**Re: IFB-C-1200444, Intrenchment Creek WRC Decommissioning and South River WRC
Primary Clarifiers**

ADDENDUM NO. 2

Addendum No. 2 - Questions for IFB-C, 1200444, Intrenchment Creek WRC Decommissioning and South River WRC Primary Clarifiers Replacement.

Drawing CY103 in Vol 1

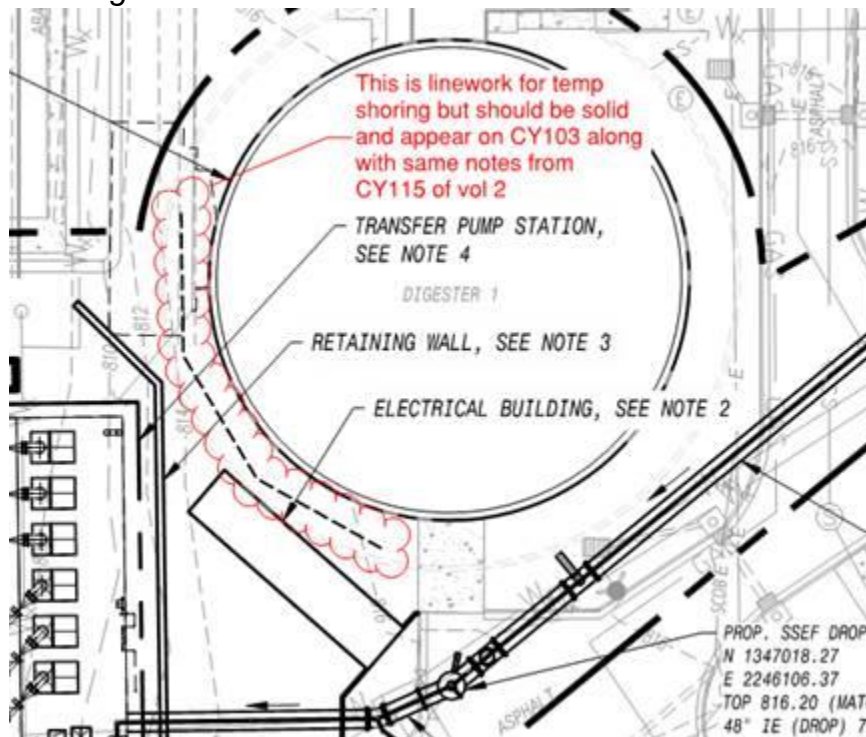
12. 1-4.01 Indicates that no additional payment above the contract price will be made for sheet piling left in place. Please confirm if support of excavation can be left in place.

Answer: Sheet piling and shoring and other excavation support systems shall be removed or left in place at Contractor's discretion. No additional payment above the Contract Price will be made for sheet piling and shoring and other excavation support components left in place. Excavation support elements left in place shall be cut off 48 inches minimum below the finish grade indicated on the Drawings. Notations should be added to drawing CY103 to clarify location and requirements of sheet piling.
